NUMBER: SB 550-32-004, Rev E
MODEL: ECLIPSE 550®
SUBJECT: Right Hand MLG Trunnion Repair/Replacement

This bulletin repairs or replaces the main landing gear trunnion.

Revision E of this Service Bulletin limits the effectivity and updates the compliance section.

Figure 1. MLG Main Fitting Nameplate Location

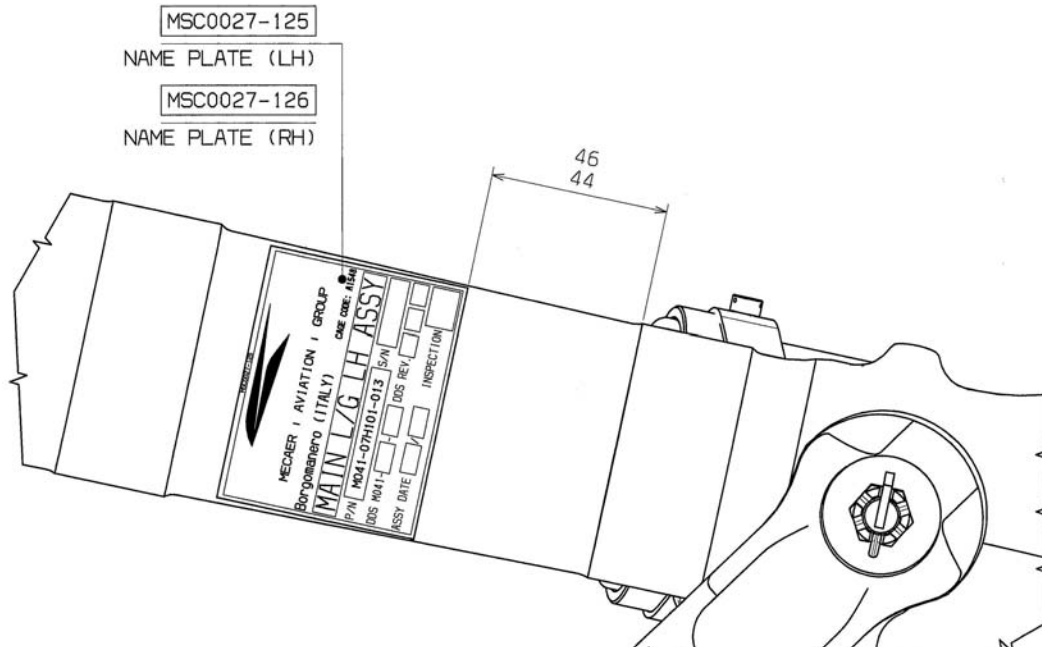
- (3) MFG DATE/ASSY DATE to remain as on the original nameplate (do not change the date to the current date).
- (4) Original nameplate shall have a large black “X” marked across the nameplate from corner to corner with permanent marker to void the nameplate. Original nameplate to remain attached to the old Main Fitting.
- (5) Locate position for new nameplate installation on the new MLG Main Fitting 44-46 mm (1.73-1.81 inch) up from the lower strengthening band in accordance with [Figure 1](#).
- (6) Pre-bend new Nameplate to conform to the contour of Main Fitting.

- (7) Prepare the Main Fitting surface in the location of the nameplate by thoroughly cleaning the surface with Aliphatic Naptha TT-N-95B Type II (or equivalent).
- (8) Ensure the Main Fitting surface is completely dry after cleaning by using a clean dry cloth.
- (9) Remove adhesive backing from the nameplate.
- (10) Apply Epoxy Adhesive MMM-A-132, Type 1, Class 3 (Metalset A4 or equivalent) under the entire surface of the nameplate.
- (11) Attach the nameplate to the MLG Main Fitting in the correct location.

- (12) Apply liberal bead of adhesive around all edges of nameplate.
- (13) Temporarily secure nameplate to Main Fitting using non-marking tape (Masking Tape or equivalent).
- (14) Allow adhesive to dry.
- (15) Remove temporary tape.
- (16) Install Trunnion per Section F. — MLG Main Fitting Installation.

Figure 2. Trunnion Identification Pad Area

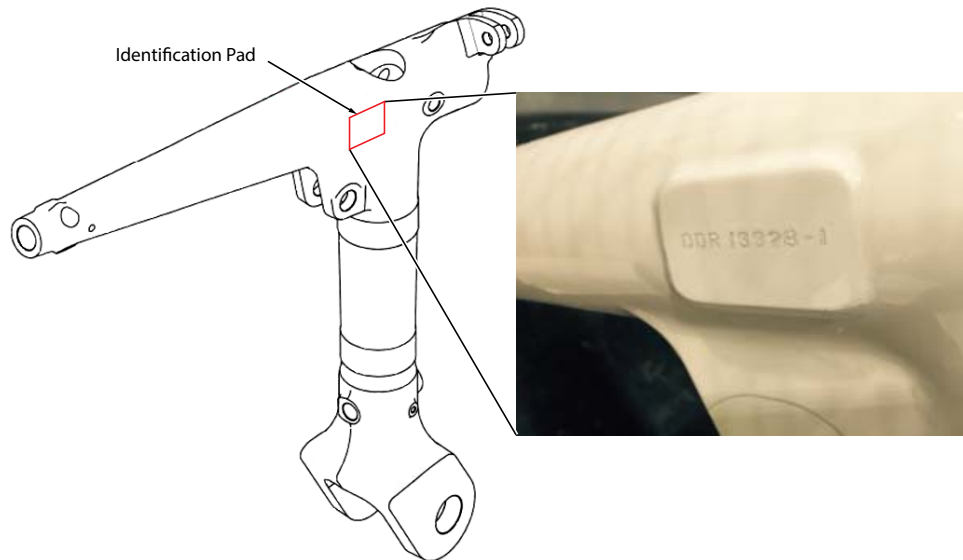
- (1) Review log book entries, proceed based upon the following:
 - (a) If trunnion was replaced per TSR from EAI, POST SB 550-32-002, and contains a Service Bulletin (SB) number and/or a DDR# as shown in [Figure 2](#), complete compliance record and return to EAI. No further work under this SB is required.
 - (b) If trunnion was not replaced, based on facility authorization, repair or replace trunnion per step 3.B. or 3.C. of this bulletin, as applicable. See “Facilities Authorized to perform Service Bulletin:” on [page 3](#).

- (1) Ensure the replacement trunnion contains at least one of the following (Refer to Figure 2):
 - Marked indication of SB completion on or near the identification pad area.
(Accomplished after repair procedure.)
 - Engraved DDR# from Mecaer on the identification pad.
